TECHNICAL BULLETIN

Issue: A nuisance issue has been identified in a small number of installations that can affect Giant Power Vent or Power Direct Vent water heater gas controls. The Giant part numbers of the gas controls affected in this bulletin are: 56000160 (Natural Gas) and 56000161 (LP). The complete gas control (modules and gas valves) impacted have a date code of up to and including 1643 (Year/Week). Below is a photograph of the gas control:

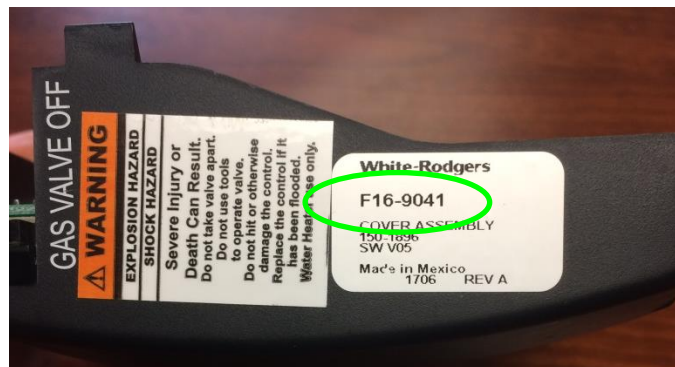
Cause: Certain abnormal voltage fluctuations can cause the gas control to enter a lockout mode and display a false error condition. **There is no "safety" concern** with this condition. Voltage fluctuations often referred to as "noise", can be generated by any inductive charges on the network (e.g.: electric motor).

How to identify the problem: All LED's are lit or all LED's but "**C**" are lit on the gas control (they may or may not be flashing).

1- Reset the gas control by turning off power to the water heater at the service panel or by unplugging the water heater for thirty (30) seconds. Restore power to resume normal operation. Note: Using the switch located on the side of the gas control will also reset the control.

2- If the issue persists, a **replacement kit (#56000162-A)** can be obtained by**:**

3- The kit will include a control module and detailed instructions on how to install it. This control module has a label on the side (#F16-9041) which identifies a software revision.
